HISTORIC AND DESIGN REVIEW COMMISSION

HDRC CASE NO: 2022-505
ADDRESS: 515 CLUB DR
LEGAL DESCRIPTION: NCB 7070 (R MATAMOROS SUB), BLOCK 9 LOT 25
ZONING: RM-4. H
CITY COUNCIL DIST.: 7
DISTRICT: Monticello Park Historic District
APPLICANT: Gilbert Garza/Garza Design-Build LLC
OWNER: Celeste Leija
TYPE OF WORK: New construction of a 1-story, single-family residence
APPLICATION RECEIVED: November 04, 2022
60-DAY REVIEW: Not applicable due to City Council Emergency Orders
CASE MANAGER: Rachel Rettaliata

The applicant is requesting a Certificate of Appropriateness for approval to construct an approximately 2,400-square-foot 1-story, single-family residential structure.

GARZA Design*Build, LLC Is Pleased to Submit this **Responses to Comments** Historic Preservation Regarding **Mr. and Mrs. Leija Proposed New Residence** located at 515-Club Dr / Monticello Park.

EXHIBIT: I II

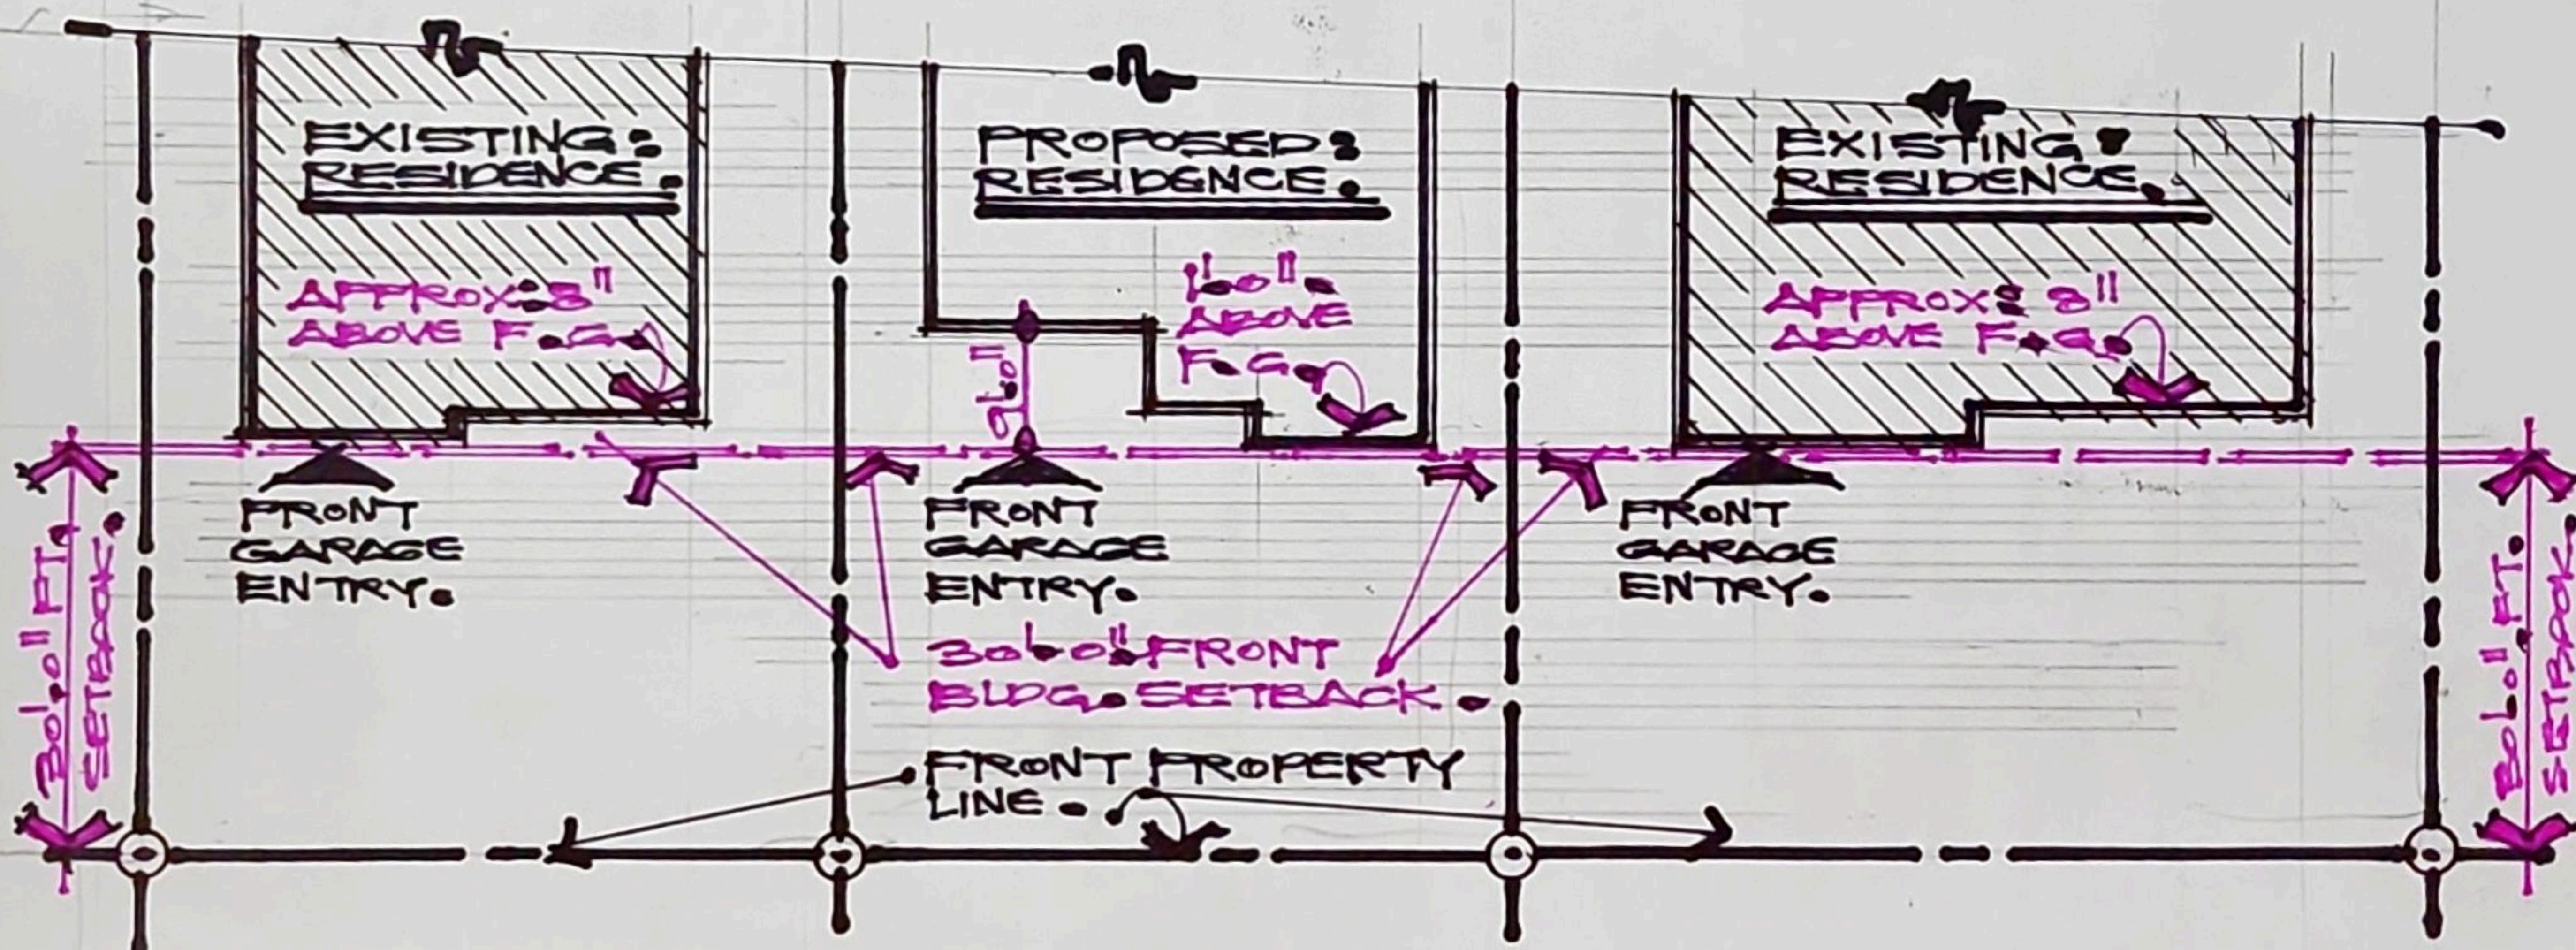
- I : Provide Setback diagram showing the Proposed setbacks in relation to the neighboring structures and Garage
 - * R. : **Setback diagram provided in previous meeting. (Article will be Re-Summitting.)**

- II : Provide Foundation heights of Proposed New Residence Construction and the 02 adjacent existing structures
 - * R. : **Foundation heights provided in previous meeting. (Article will be Re-Submitted.)**

FRONT SETBACK NOTE: EXISTING RESIDENCE AT LEFT AND RIGHT OF PROPOSED ARE ALL AT THE 30' 0" FT. BLDG. SETBACK.

02. PROPOSED: GARAGE DOOR OPTION'S.

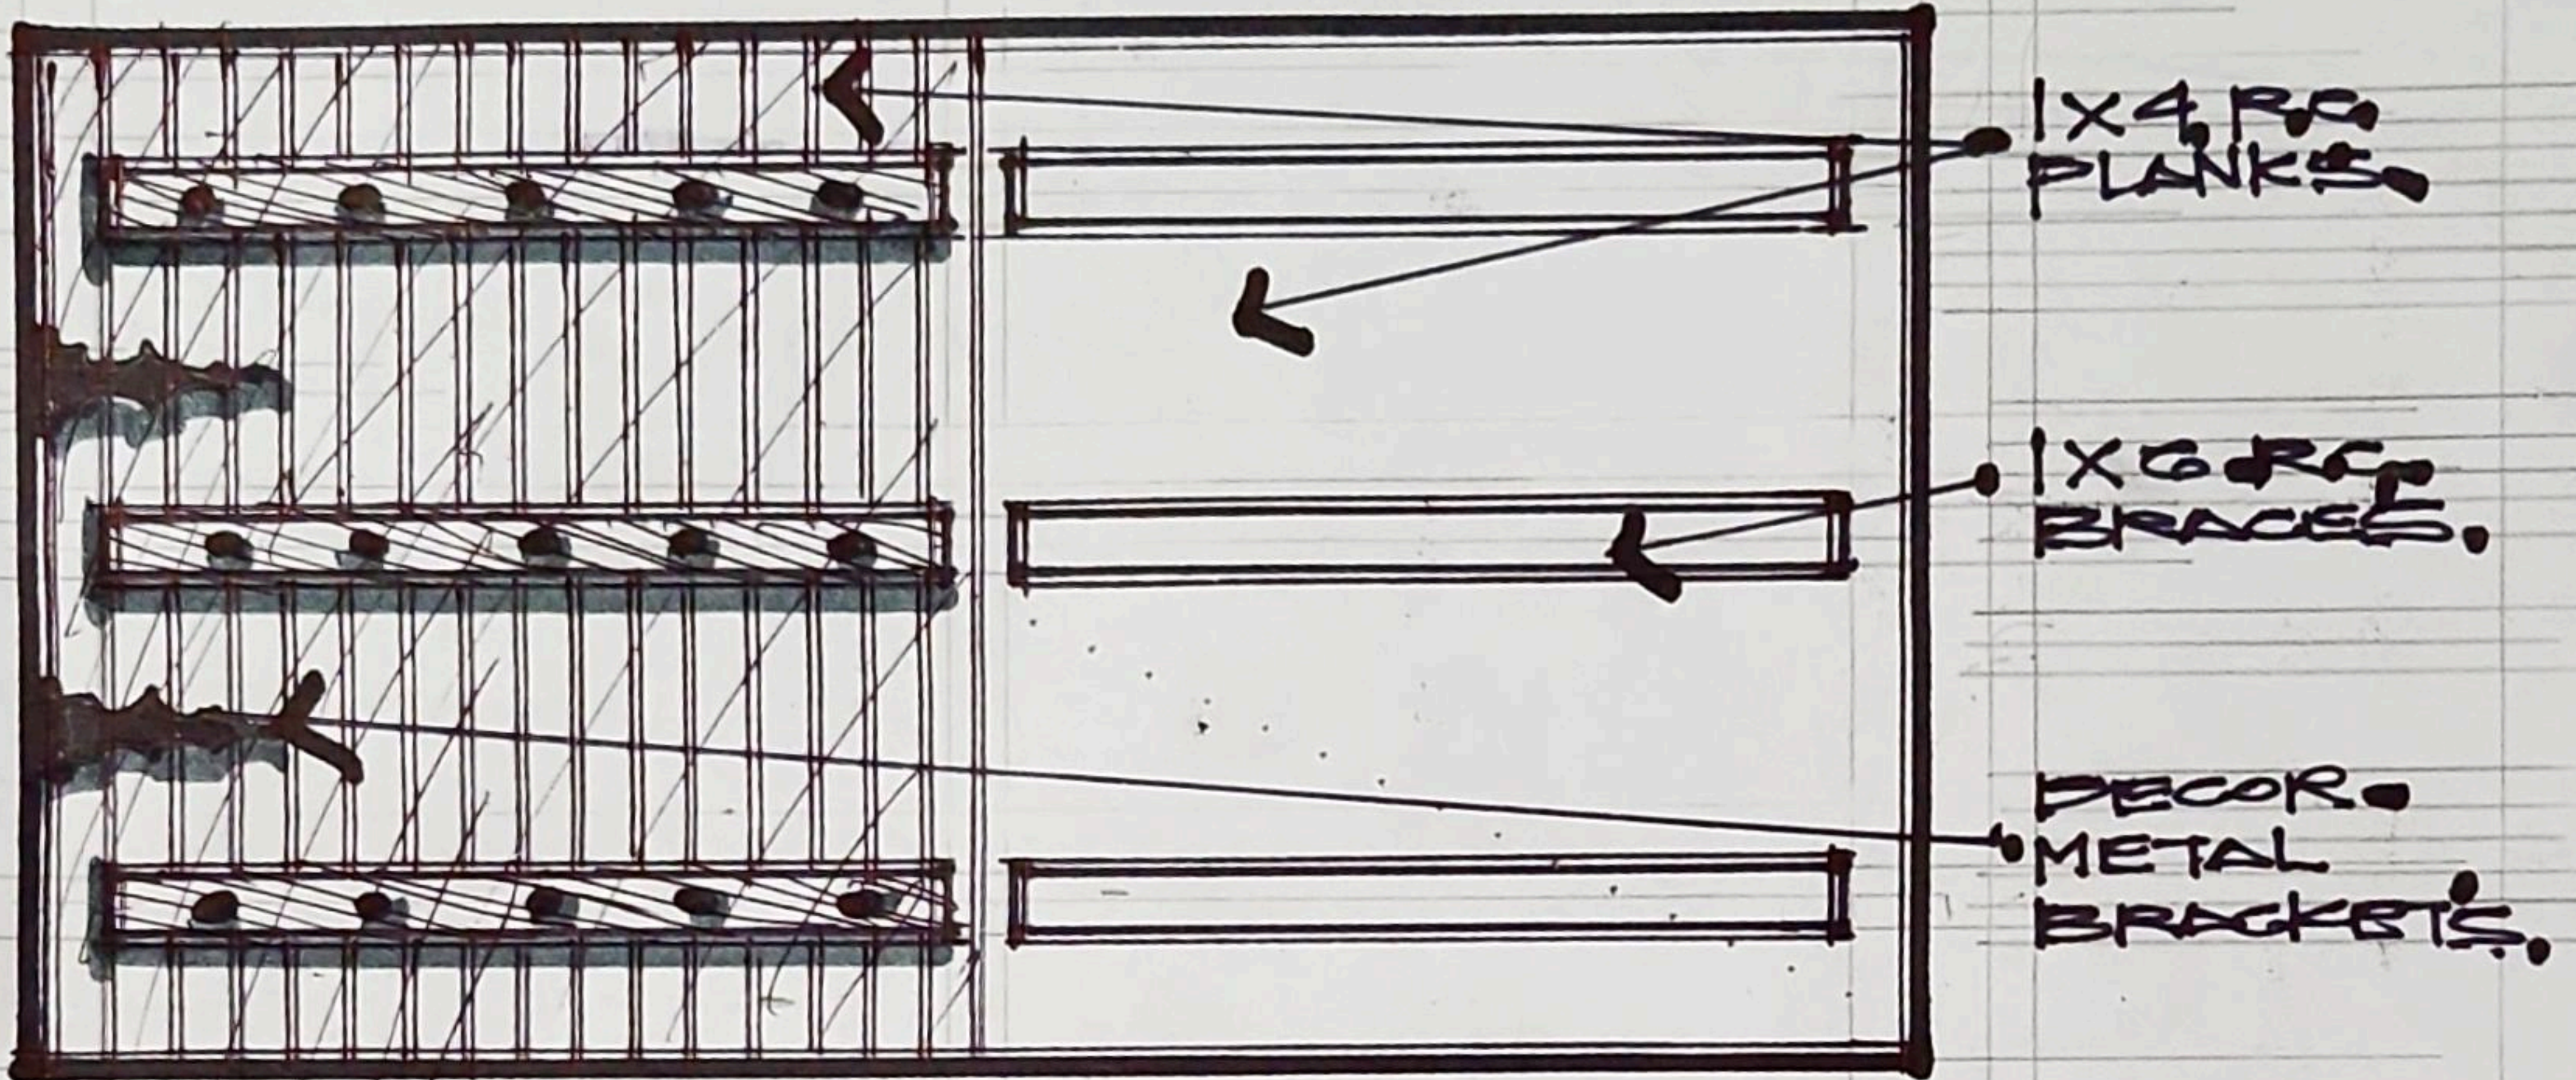
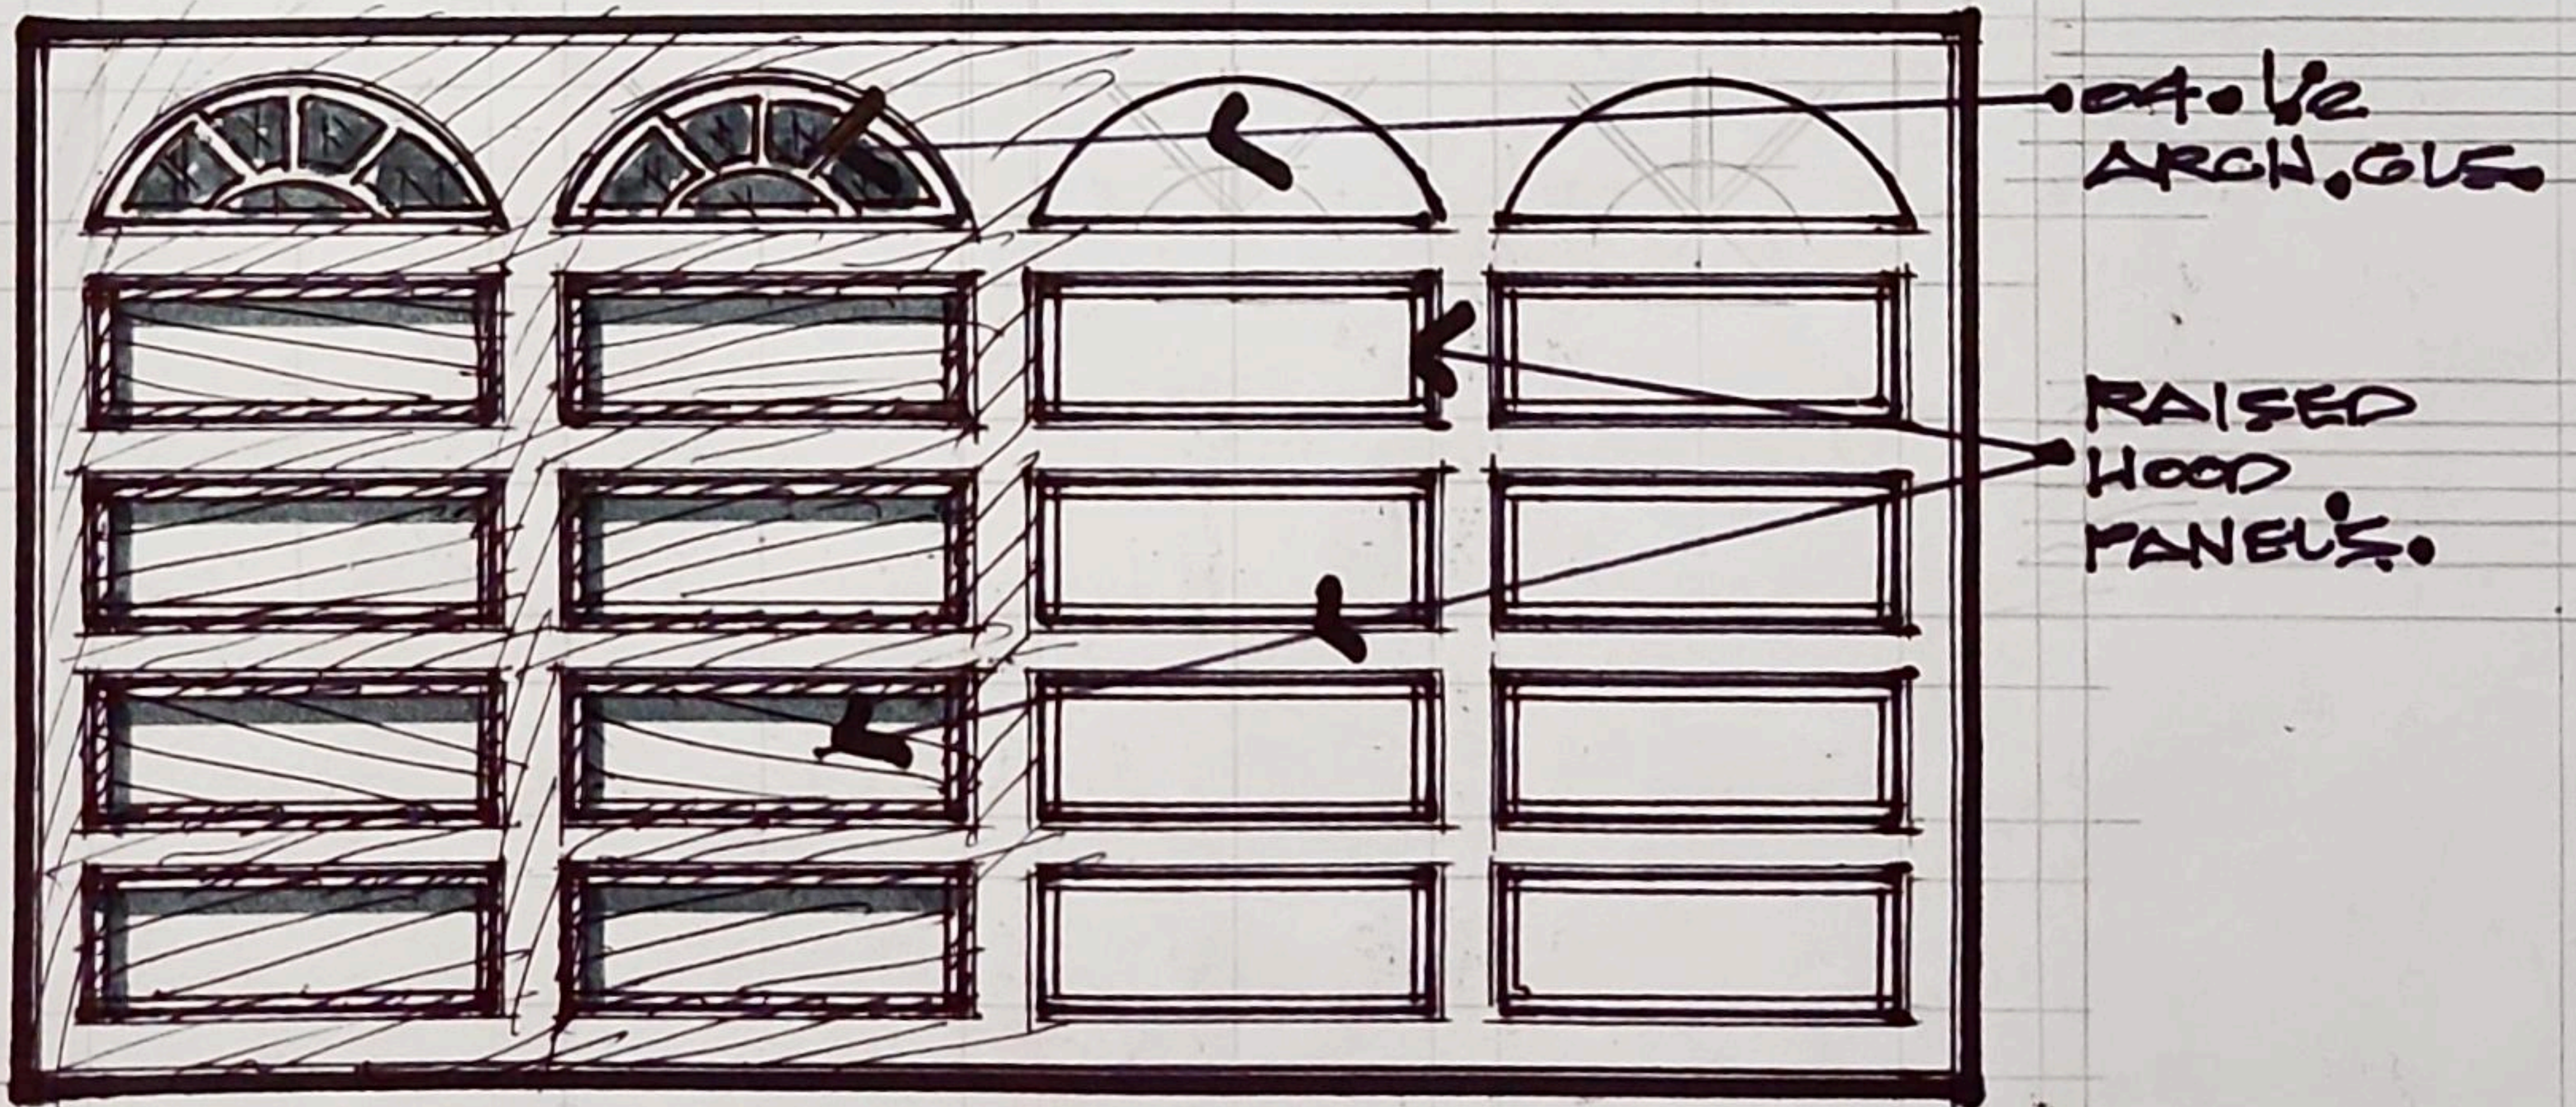
- vii. That the front facing garage door product selection is made with attention to detail so that the garage doors do not over-dominate. ***This stipulation has been met.***

- 0 : **Proposed Garage Doors "02 - Design Options"**
 - * R. : **Refer, to Attached Drawings.**
